Pre-Application Conference Notes

PAC 2025-002: 15665 SW Willamette Street

Meeting Date – February 27, 2025

Proposed Project Name:	Sherwood Old Town Apartments
Proposal Description:	A Pre-Application Conference for twenty-seven (27) unit multi-family development. The subject parcel is zoned High Density Residential (HDR) – Old Town Overlay, approximately 1.14 acres in size, and located at 15665 SW Willamette Street (Washington County Assessors Map and Tax Lot Number: 2S132BD/400).
Applicant:	Adrian Oltean 8101 SW Nyberg Street, Suite 202 Tualatin, OR 97062
Owner:	Elton Family Fund 1 LLC
Site Address:	2541 E GALA ST STE 310, Meridian, ID 83642
Tax Lot ID:	2S132BD00400
Land Use Designation:	High Density Residential-HDR (HDR) – Old Town Overlay

PROPOSED SITE PLAN
-1 STRUCTURE W/ 3 STORIES
-27 UNITS
-36 PARKING SPACES

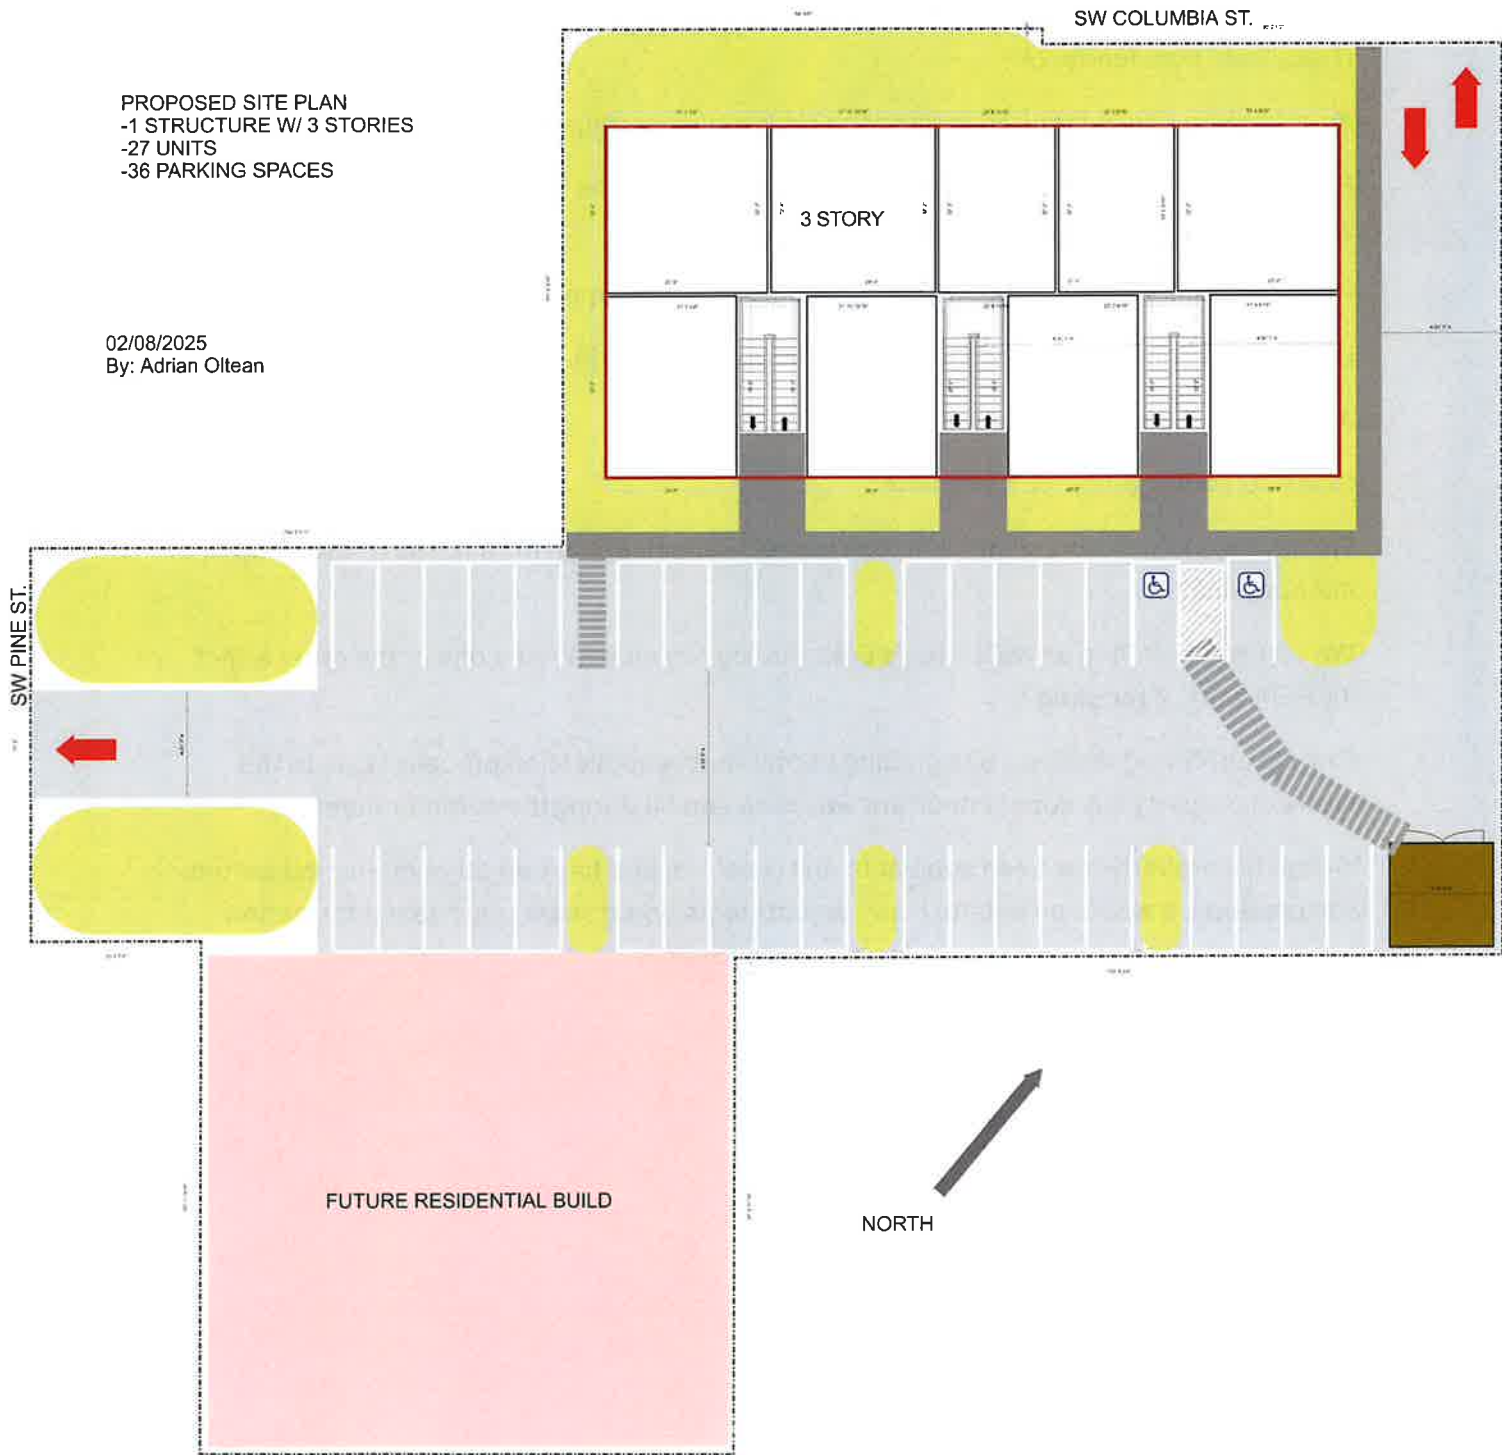
Planners Note: review of the submitted materials did not indicate an amount or location for dedicated bicycle parking. Based on the current off-street parking ratios, the applicant is required to provide a minimum of four (4) dedicated bicycle stalls ($36/10 = 3.6$) meeting the minimum dimensional and location standards, pursuant to 16.94.020.C.2.

Planner Note: Review of the submitted materials do not delineate a common open space area. This will need to be adequately addressed prior to submittal. Staff recommend an application include site details about the specific layout, feature, and amenities of the dedicated open space.

- What information is on file about the mitigation process?
 - Overall site plan feedback?
 - Any common space required in this zone? In building or property

Figure 1: Lot 1 at 40,157 SF with requested variance

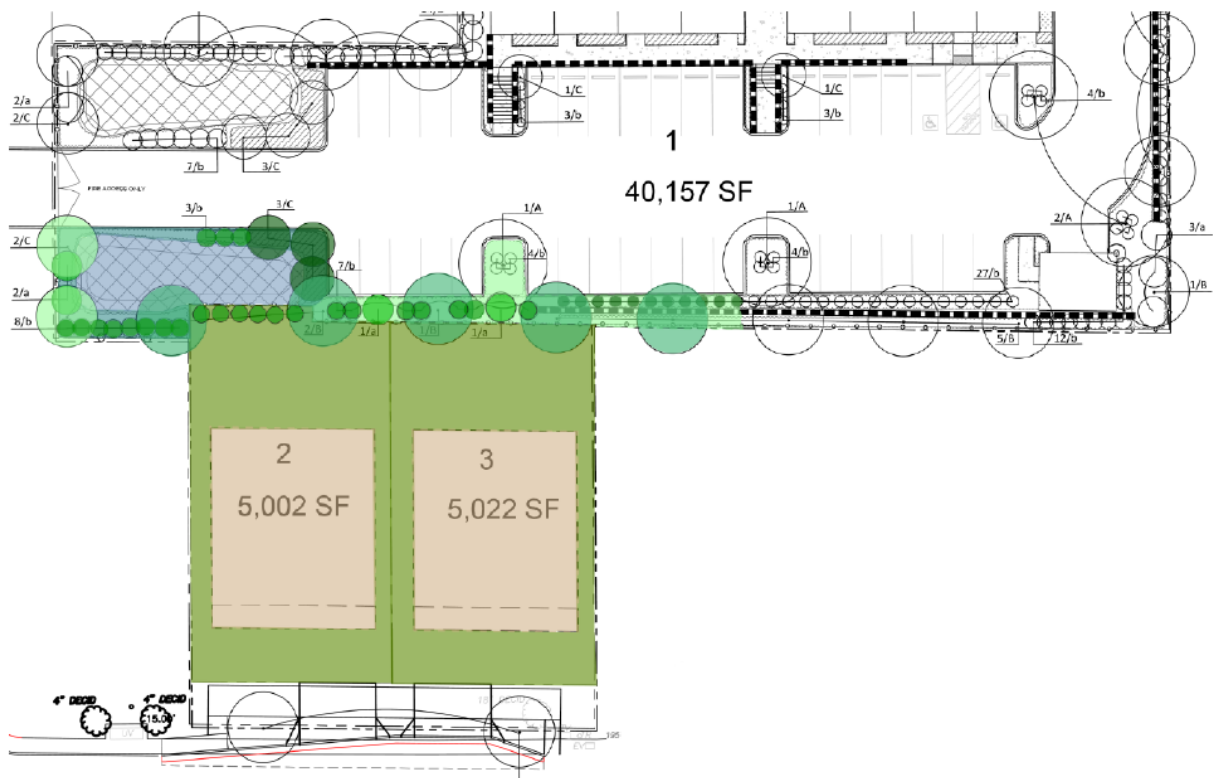
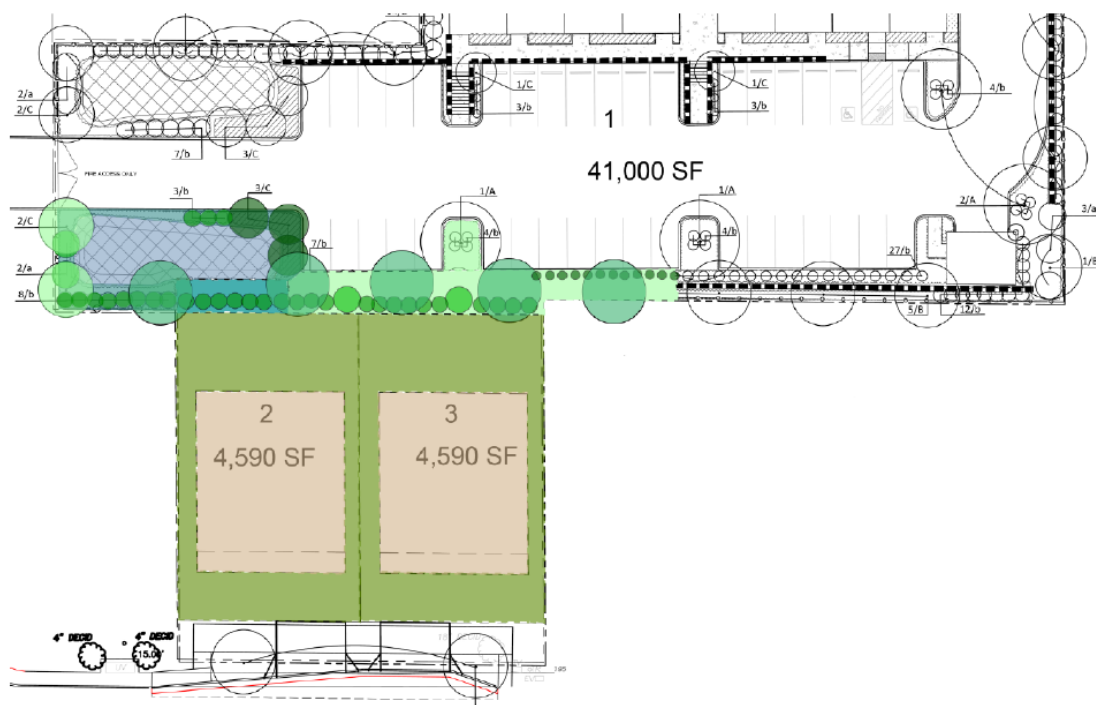
ANALYSIS: Staff concurs with the applicant response. As shown in Figures 1 and 2 above, the loss of 843 SF on Lot 1 will allow a more compatible development type (single-family homes) along SW Willamette St. while having a minimal impact to the multi-family lot.
